## Autonomous Audio Headset Switch

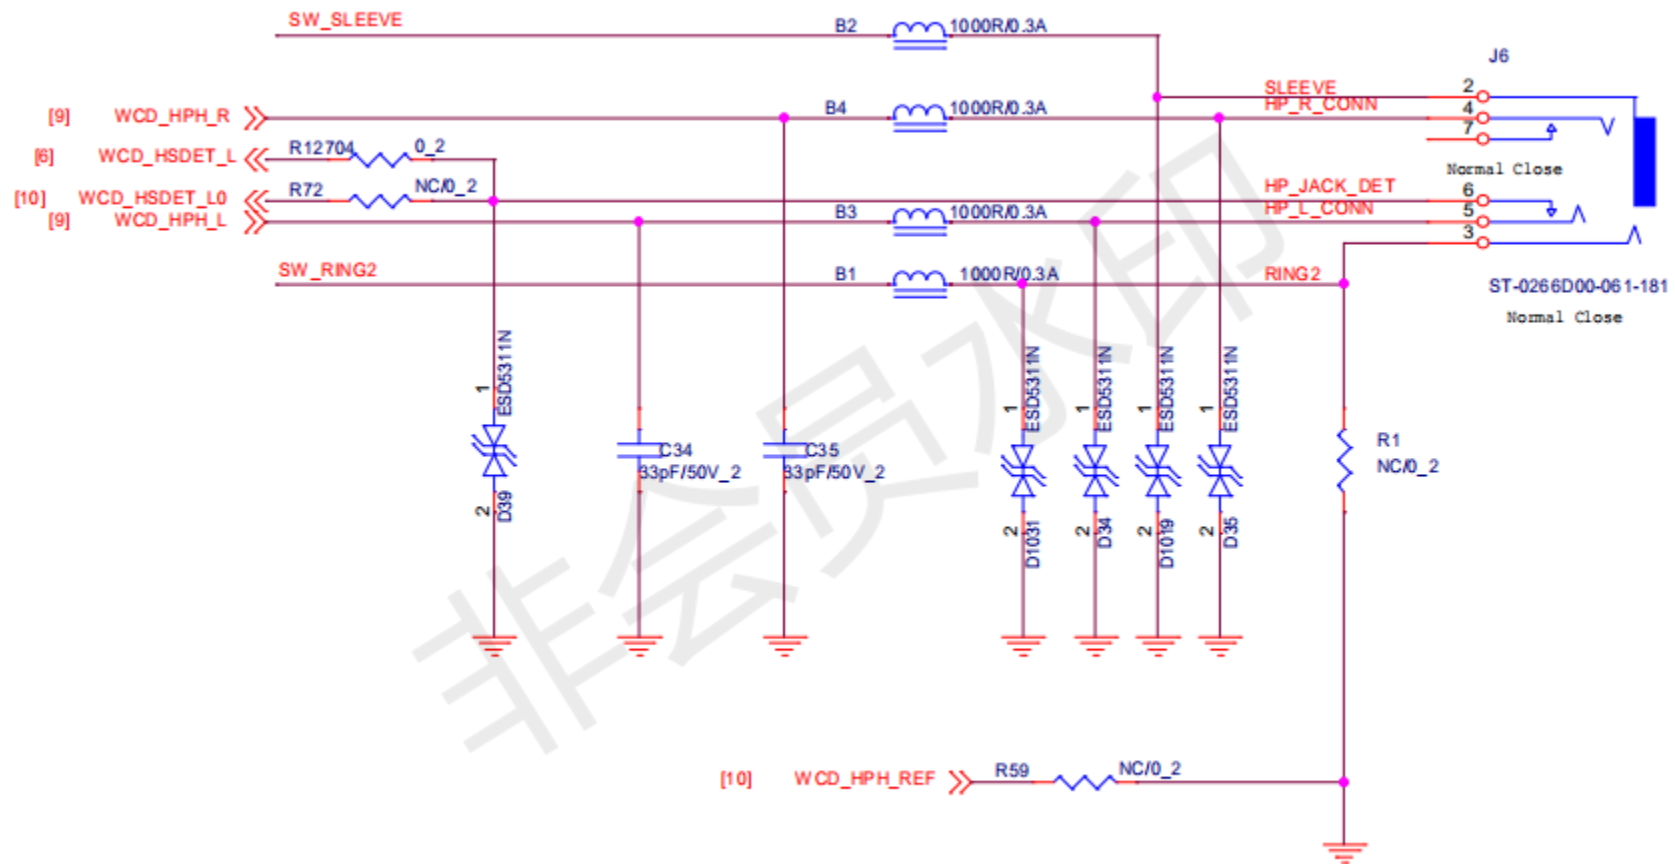
cdc\_hph\_ref needs to be between CDC\_HPH\_L/R
